Addendum No. 1
City of Coquitlam
Tender No. 81832 – Phase 2
2026 & 2027 Cedar Drive Upgrades
 (Consists of 28 Pages)
 Issue Date: January 20, 2026

Contract 81832 - Phase 2
2026 & 2027 Cedar Drive Upgrades

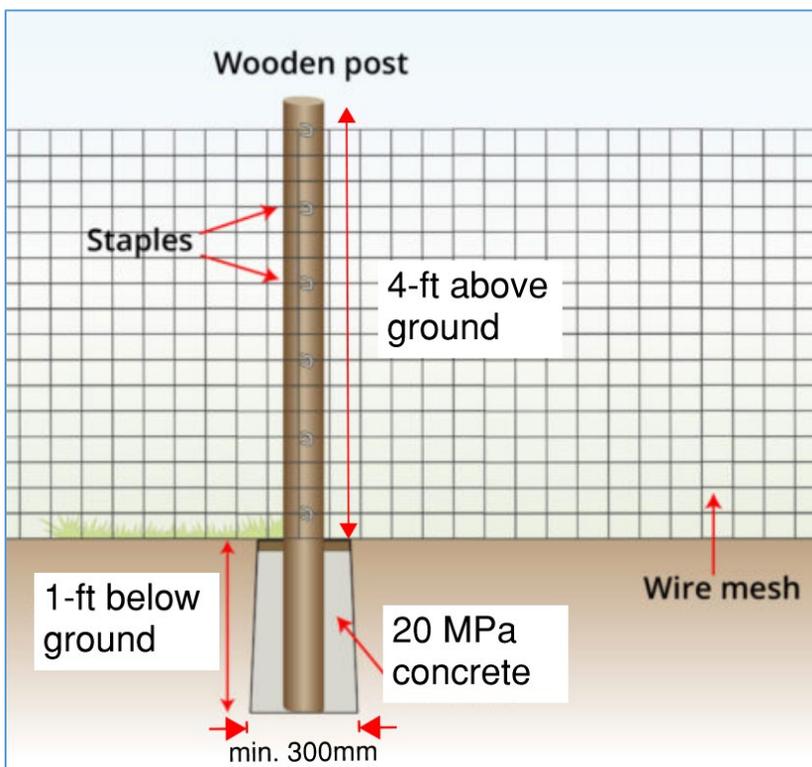
Q2) Could you please provide details for item 18.06 – 5 ft barbed wire fence?

A2) Refer to *Revised* – Appendix 1 – *Revision No. 1* for revised pay item description and to above Revision 6 for updated specification. Tenderers are referred to the below historic photo of the fence at 4265 Cedar Dr and installation sketch for reference.

“Payment under this item will include supply and installation of wire mesh fence c/w 5-foot tall (incl. 1-foot buried) and 100mm diameter wooden posts spaced at 3-metres separation, 15-

gauge welded wire galvanized steel netting fence with 2-inch x 4-inch mesh, staples, and concrete base for buried portion of wooden post.”
